REVISED RESPONSE TO REQUEST FOR ADDITIONAL INFORMATION

APR1400 Design Certification

Docket No. 52-046

RAI No.: 481-8546
Review Section: 16 – Technical Specifications
Application Section: 16.3.4, 16.3.5, 16.3.6, 16.3.7, 16.3.9
Date of RAI Issue: 09/04/2015

Figure 1 RCS Elevation View

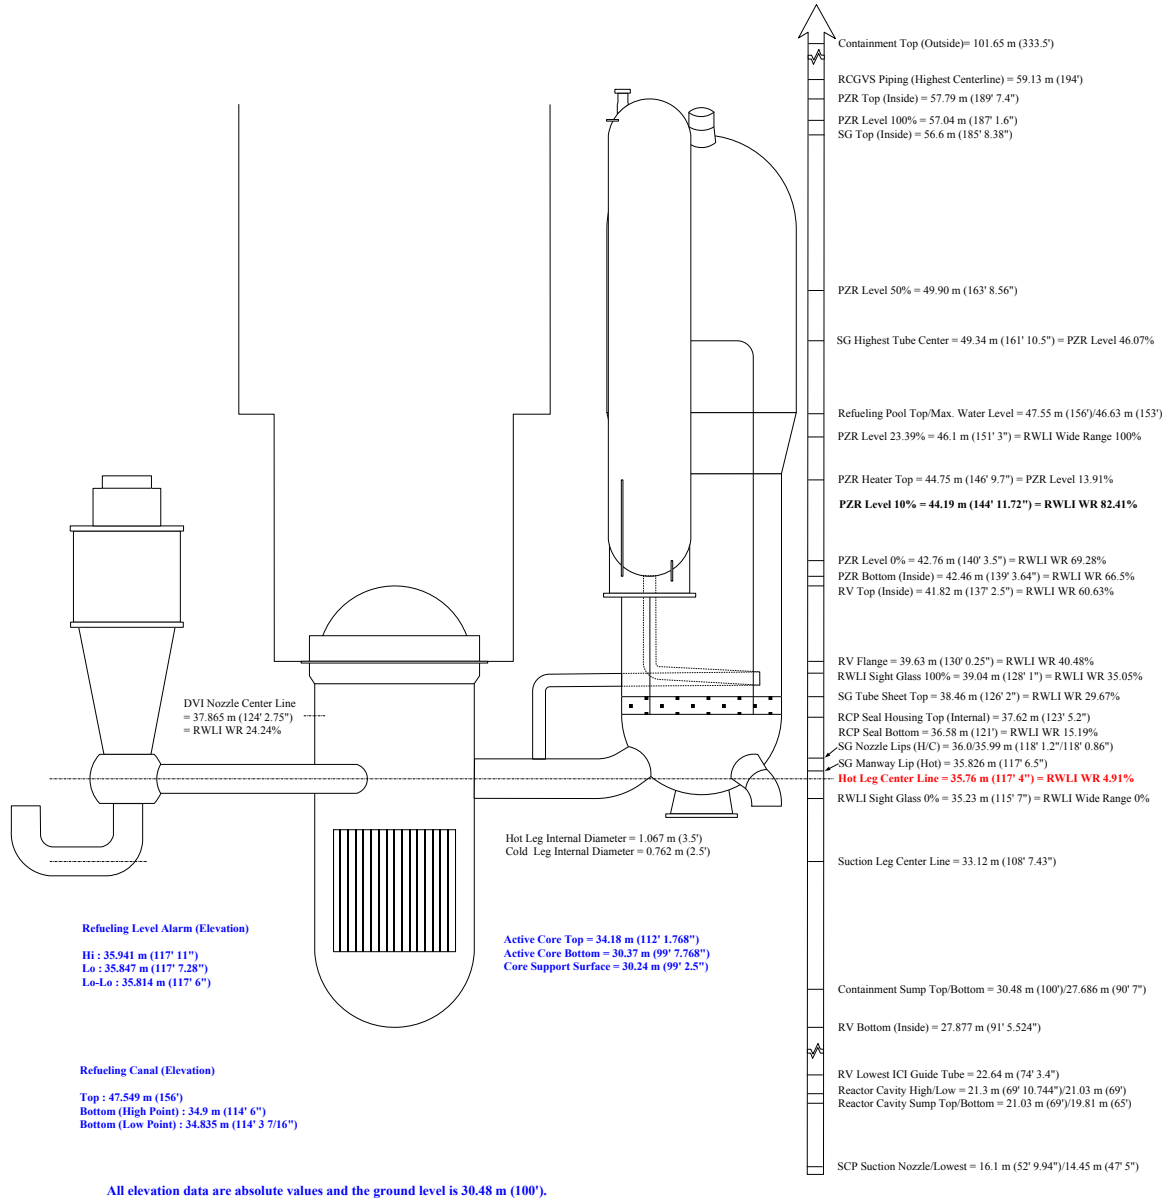
- 2.K A description on an entry condition into the loops filled or the loops not filled will be added in Applicability sections of B3.4.7 and B3.4.8 as follows;

The MODE 5 with RCS loops filled condition is when the steam generators (SGs) can be used for the core decay heat removal. This loops filled condition can be maintained while draining the RCS provided the reactor coolant level is maintained above 134 ft, since below this level, containment atmospheric pressure can no longer completely support the column of water remaining in the SG tubes above the reactor coolant level. At reactor coolant level below 134 ft, water vapor voids begin forming in the horizontal portions of SG tubes, beginning with the highest tubes. The number of affected tubes increases as RCS level decreases until all tubes contain water vapor voids. SG tubes containing voids of water vapor, at the saturation temperature corresponding to vapor pressure of the coolant in the tubes, block coolant flow and secondary heat transfer. When reactor coolant level has decreased to 119 ft 1 in (just above the highest point of the hot leg), air can begin entering the hot leg through the surge line connection and displace the coolant remaining in the SG tubes. This results in the SG tubes being filled with non-condensable gases. The condition in MODE 5 with RCS water level within the top half of the hot legs is called mid-loop operation.

Restoring the unit to the MODE 5 with RCS loops filled condition requires raising RCS level above 134 ft during a draining operation, provided no air was introduced into the

SG tubes. Restoring the unit to the MODE 5 with RCS loops filled condition following mid-loop operation requires closing the pressurizer manway, filling the pressurizer, and dynamically venting non-condensable gases from the SG tubes and reactor vessel closure head using the RCGVS and the reactor coolant pumps.

A forced circulation by the reactor coolant pumps (RCPs) in the MODE 5 with loops not filled condition is possible when the static head of the water from pressurizer water level establishes an RCS pressure high enough to run an RCP.

Insert the content "A" in the next sheet.

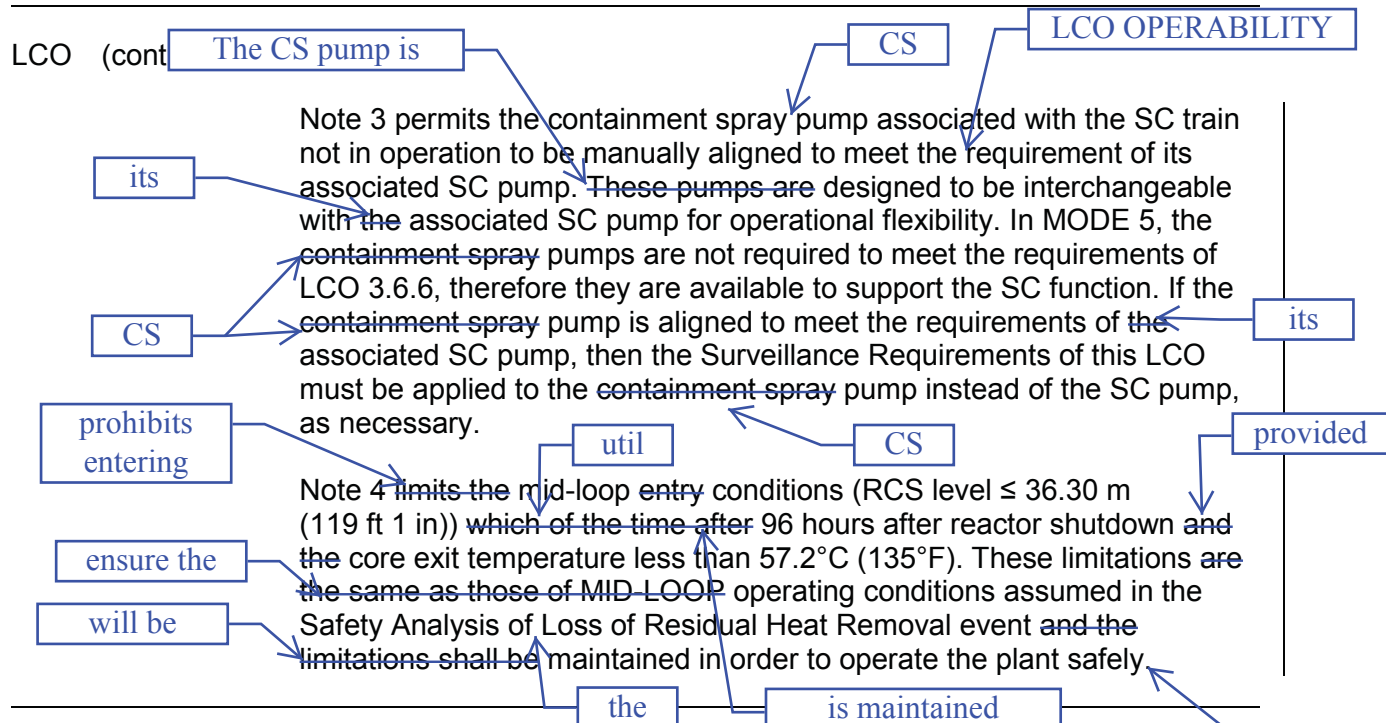
In MODE 5 with RCS loops filled, this LCO requires forced circulation to remove decay heat from the core and to provide proper boron mixing. One SC train provides sufficient circulation for these purposes.

The MODE 5 with RCS loops filled condition is when the steam generators (SGs) can be used for the core decay heat removal. This loops filled condition can be maintained while draining the RCS provided the reactor coolant level is maintained above 134 ft, since below this level, containment atmospheric pressure can no longer completely support the column of water remaining in the SG tubes above the reactor coolant level. At reactor coolant level below 134 ft, water vapor voids begin forming in the horizontal portions of SG tubes, beginning with the highest tubes. The number of affected tubes increases as RCS level decreases until all tubes contain water vapor voids. SG tubes containing voids of water vapor, at the saturation temperature vapor pressure of the coolant in the tubes, block coolant flow and secondary heat transfer. When reactor coolant level has decreased to 119 ft 1 in (just above the high point of the hot leg), air can begin entering the hot leg through the surge line connection and displace the coolant remaining in the SG tubes. This results in the SG tubes being filled with non-condensable gases. The condition in MODE 5 with RCS water level within the top half of the hot legs is called mid-loop operation.

Restoring the unit to the MODE 5 with RCS loops filled condition requires raising RCS level above 134 ft during a draining operation, provided no air was introduced into the SG tubes. Restoring the unit to the MODE 5 with RCS loops filled condition following mid-loop operation requires closing the pressurizer manway, filling the pressurizer, and dynamically venting non-condensable gases from the SG tubes and RPV closure head using the RCGVS and the reactor coolant pumps.

A forced circulation by the reactor coolant pumps (RCPs) in the MODE 5 with loops not filled condition is possible when the static head of the water from pressurizer water level establishes an RCS pressure high enough to run an RCP.
